File
PUD-98-006

**AMENDMENT TO BROOKMOOR PUD
COLORADO HOMES AND LIFE STYLE and MARTIN DELOHERY**

A request by Colorado Homes and Life Style and Martin Delohery to amend the existing development plan for Brookmoor. The property is currently zoned PUD (Planned Unit Development) District. The proposed change is to add a six foot berm along Lake Woodmoor Drive. The property is located on the north side of State Highway 105, south of Lake Woodmoor Drive and west of the westerly terminus of South Park Drive in the Woodmoor area. Tax schedule #'s 71141-00-012, 013. Approval includes authorization for the Chairman to sign the Development Plan/ Guide.

A request by Colorado Homes and Life Style and Martin Delohery to amend the existing Development Plan for Brookmoor. The property is currently zoned PUD (Planned Unit Development) District. The proposed changes are: revise entrance and gatehouse area, reduce setbacks, delete sidewalks, replace perimeter fence with landscaping, change fence along Woodmoor Drive to split rail and add a six foot berm along Lake Woodmoor Drive. The property is located on the north side of State Highway 105, south of Lake Woodmoor Drive and west of the westerly

PROPOSED GATEHOUSE AND ENTRYWAY.

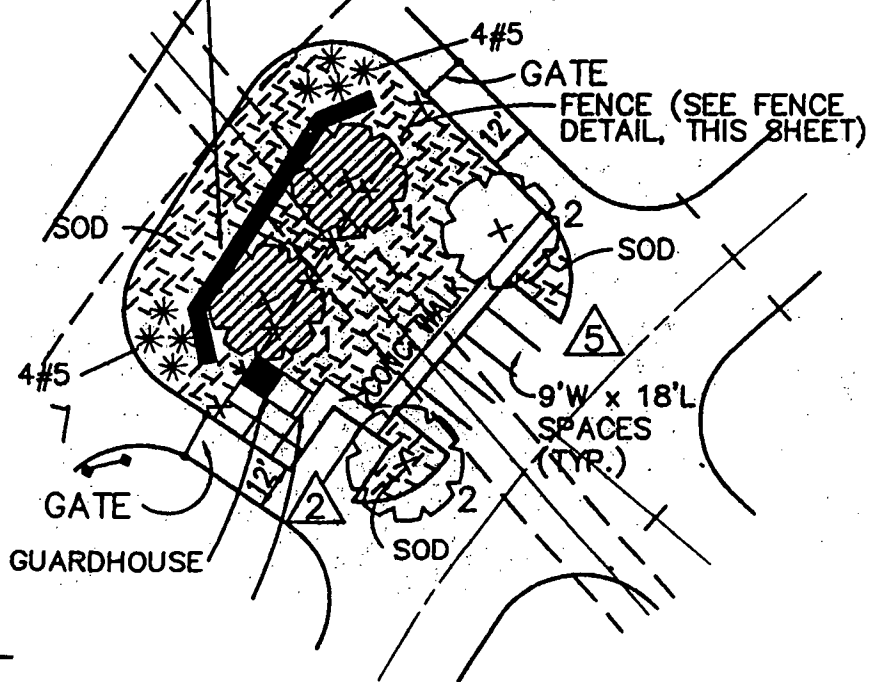
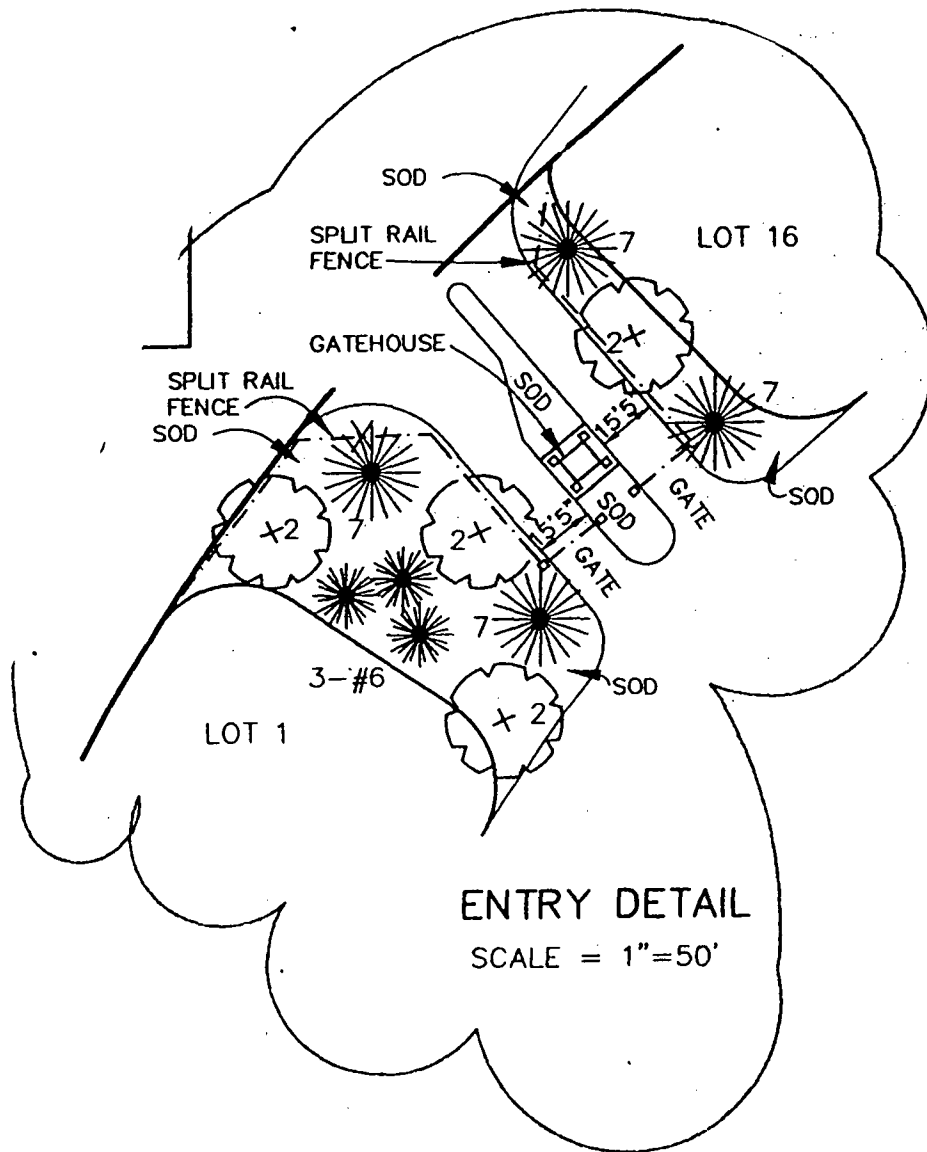
The applicant is proposing to amend the approved development plan for Brookmoor. The proposed changes to the gatehouse/entryway and the fence along Woodmoor Drive appear to be minor changes and are included as attachments. Replacing the perimeter fencing with landscaping seems to take away from the concept of a "gated community" but the developer believes it will be more aesthetically pleasing. It appears from the plans the berm will be contained in the 25 foot building setback, which is required, along Lake Woodmoor Drive. The developer indicated the berm would provide privacy for the homes which would be located along Lake Woodmoor Drive. As the berm is contained within the building setback it will not affect where homes could be located.

PROPOSED FENCE

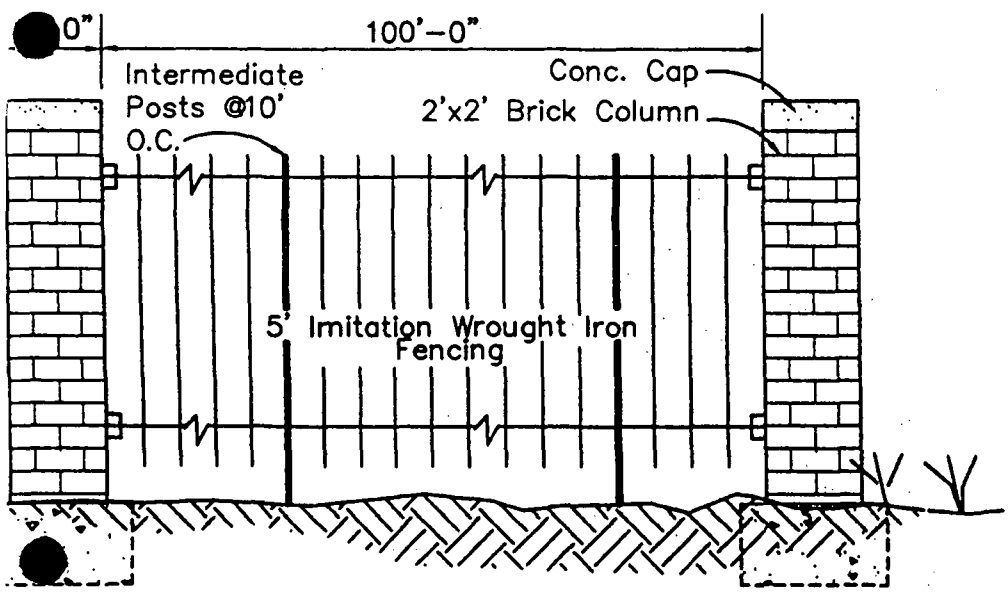
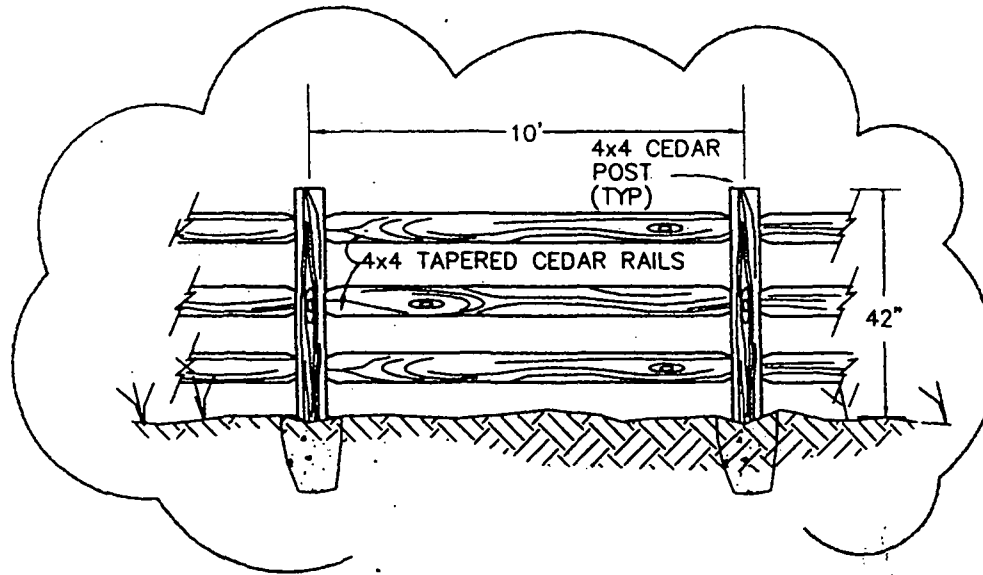
- 4) The applicant is proposing to change the fencing type from wrought iron with brick pillars to a split rail, and discusses in the letter of intent their reasons for this. The Town would have to ask what is the purpose of the fence. If this is to be a gated community with a specific gatehouse, it would seem reasonable to conclude that security has been regarded as an issue. A wrought iron fence with brick pillars lends itself more to maintaining security than does a split rail fence.

6' BERM
2:1 SLOPE

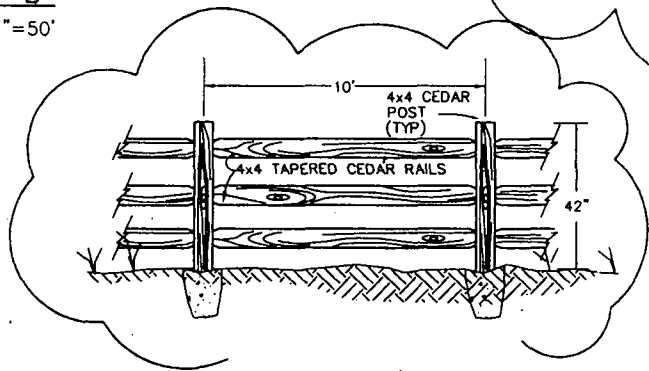
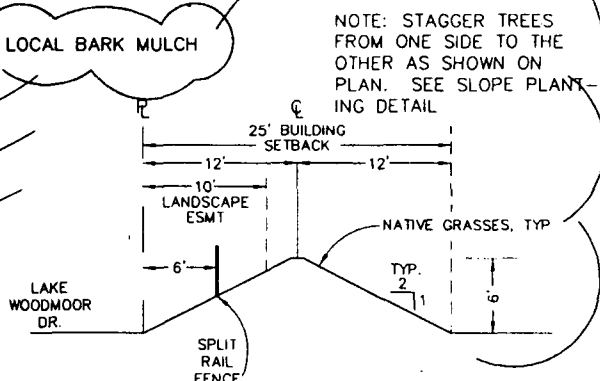
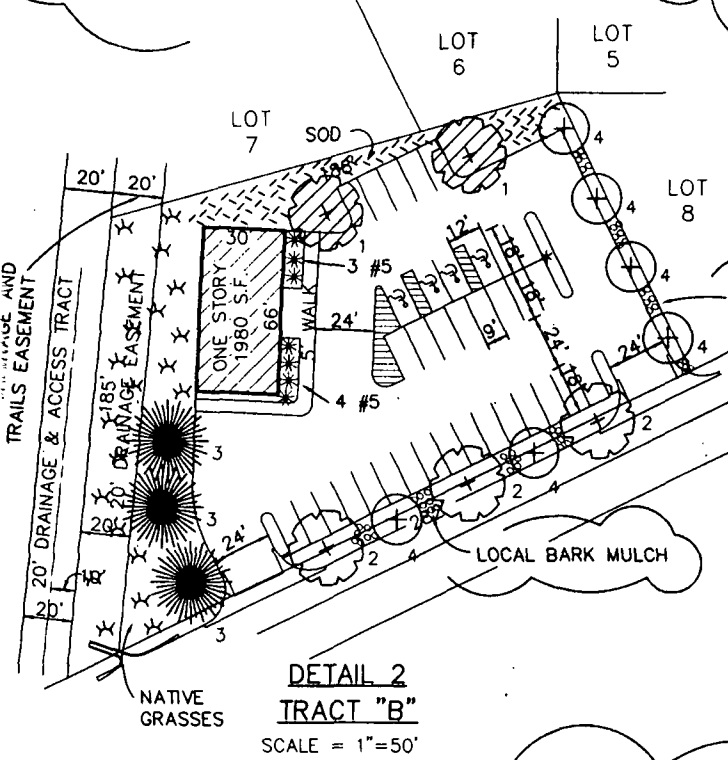
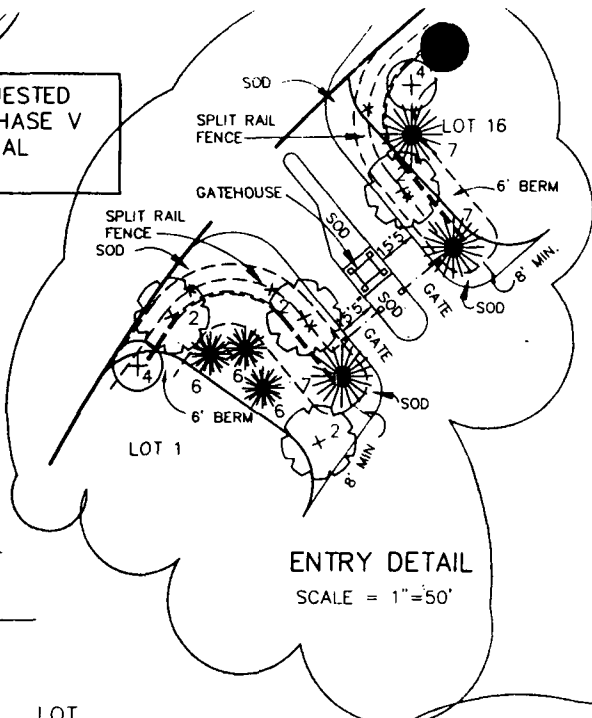
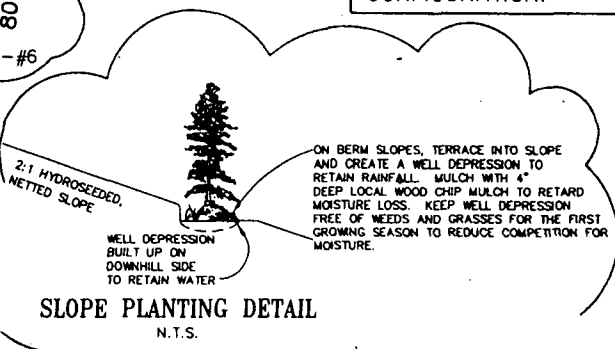
EL PASO COUNTY DEPARTMENT OF TRANSPORTATION (response to September 15, 1998 request) - The P.U.D. Development Plan indicates a different berm cross-section and access configuration from what is shown on the construction plans. The revised grading on the construction plans is not clear. Assuming the construction plans are correct, the berm (and proposed vegetation) will need to be removed near the entry road to provide safe sight visibility for vehicles entering and leaving the subdivision.

Please resubmit the grading and erosion control of the berm as a detail at a revised scale.

A twenty-five foot sight triangle needs to be provided on the Development Plan on either side of the access point.

It appears that at least portions of the berm have already been constructed without any erosion control measures being implemented.

1. Prior to issuance of building permits the property shall be in compliance with the approved grading plan as determined by the El Paso County Department of Transportation. The berm along Lake Woodmoor Drive shall not be located in the right-of-way.

9 ③ A twenty-five (25) foot sight triangle shall be provided on the Development Plan on either side of the access point.
